From: Lynda Griffin
Sent: 23 July 2021 16:44
To: h.leach@bury.gov.uk
Cc: Alan Lowe; Andrew Charnock; Darren Embury; eplanner@metrolink.co.uk; Landuse; Projects@metrolink.co.uk; rapidtransit.development@tfgm.com (rapidtransit.development@tfgm.com)
Subject: RE: Planning Application 66674 Consultation - Former nursery building and land to rear of Earl Street, Prestwich

Planning Ref: 66674

Proposal: Change of use of former nursery building to form 4 no.dwellings; Demolition of existing garage units to create 13.no dwellings with associated external works

Location: Former nursery building and land to rear of Earl Street, Prestwich, Manchester, M25 1GQ

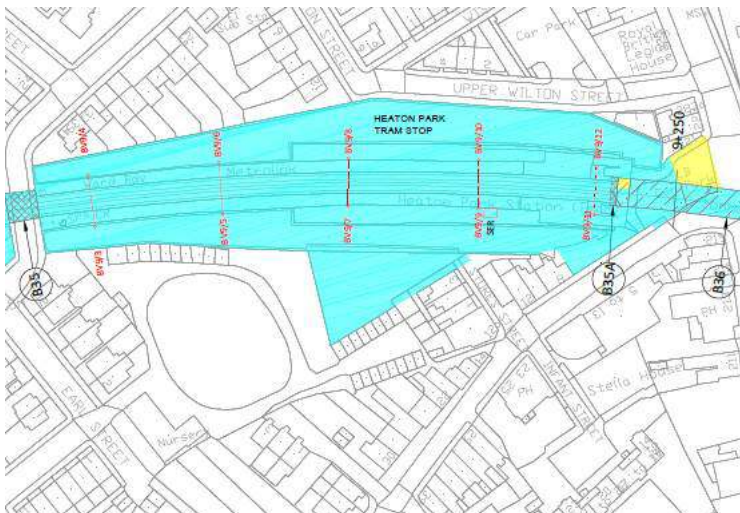
This proposed development site incorporates land within their area edged red that is currently owned by Metrolink. Our Agents have been in contact with the Applicant in this regard but there has been no agreement to the sale/purchase of land. The image below shows the extents of Metrolink's ownership and whilst much of the Metrolink land is in the area to remain as existing there is some used in the developed area. In addition to this, the development adjoins the Metrolink boundary and has, due to its close proximity, potential to adversely impact Metrolink infrastructure and operations. Whilst it is considered that there are aspects that could easily be resolved and agreed the layout as presented would undoubtedly and irreparably impact the trees within Metrolink land, which in turn could destabilize the embankment, additional information on this and other aspects are set out below. In view of the foregoing Metrolink must unfortunately object to this Application as currently submitted.

Metrolink runs in a cutting adjacent to the site, see image below, and it is important that the cutting slope, the retaining structures and the trees between the property boundary and the tramway are not de-stabilized by the works on the site or by changes to the drainage in the vicinity. The destabilization of trees (which could take as much as 5 years before any damage to the root protection areas become apparent) will in turn destabilize the cutting slope. It is therefore extremely important that a realistic assessment of the likely impact on the tree roots is fully understood and addressed at this stage.
